Ting and Verizon Infrastructure Deployment  
Requests

**MEMO TO:** Parkfairfax Board of Directors  
**FROM:** Mike Rothenberg, Ward 1 Board Representative & BUC Liaison  
**SUBJECT:** Verizon and Ting Agenda Item  
**DATE:** June 21, 2024

**CONNECTED ATTIC**

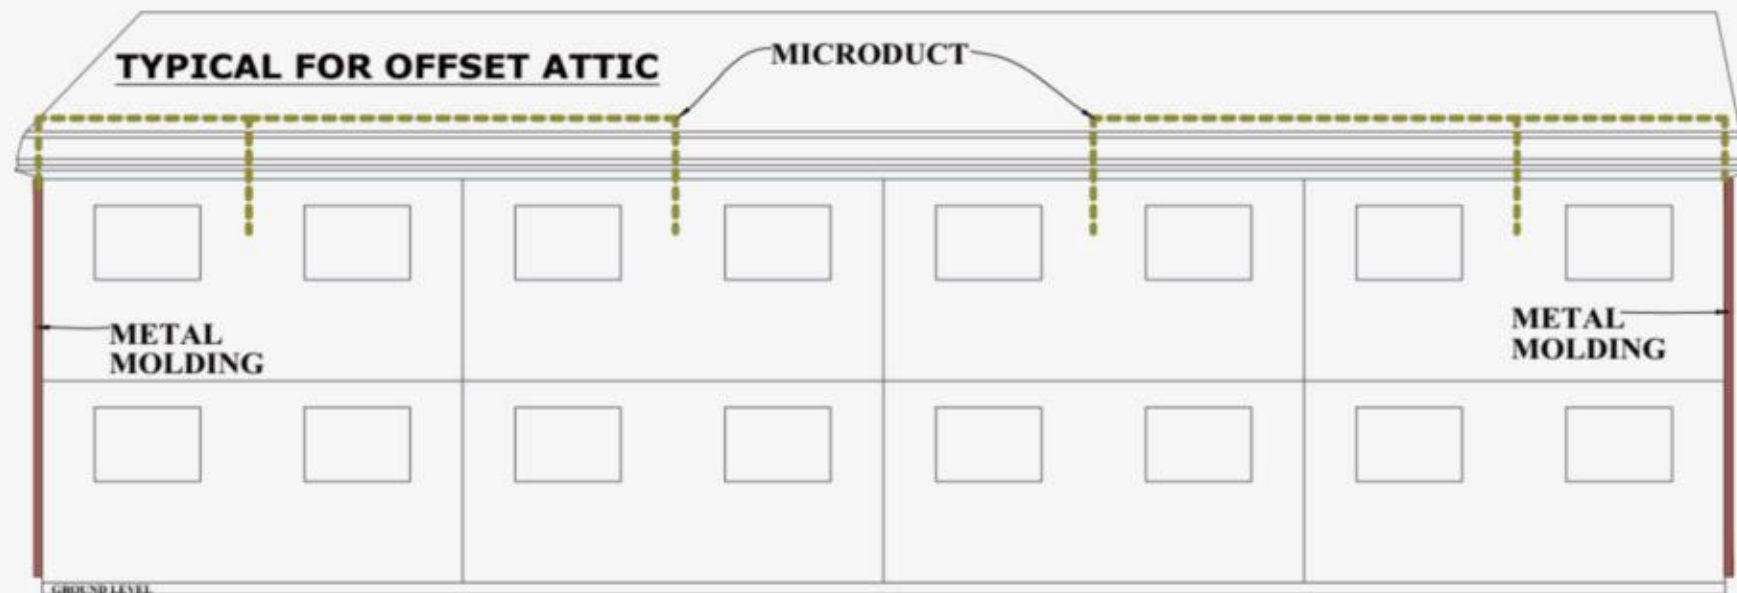
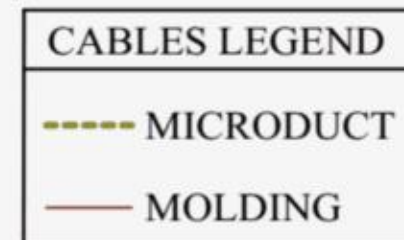
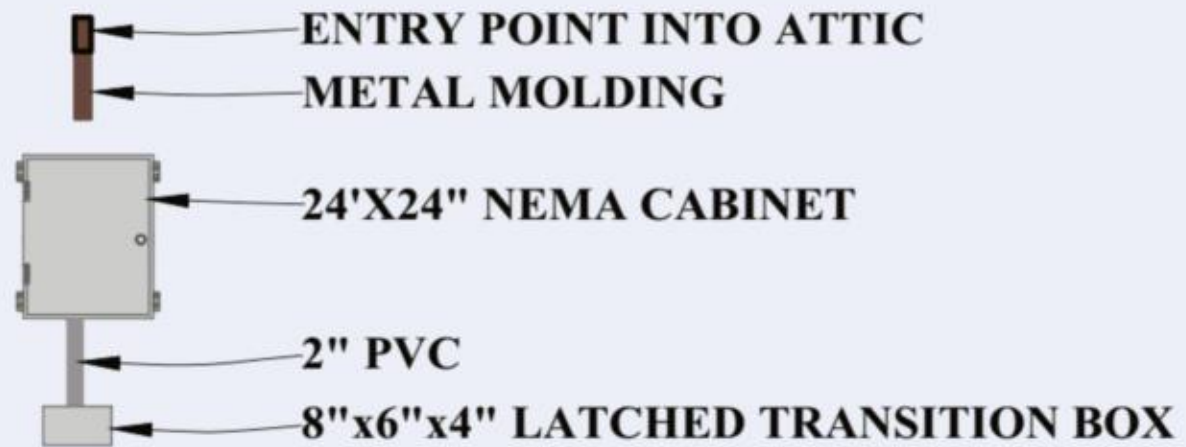
- Also, Verizon mentions running the fiber cable the width of buildings in the attics, which raises concerns about how this could impact the decommissioned pipes wrapped in asbestos insulation and residents' use of the attics for storage.
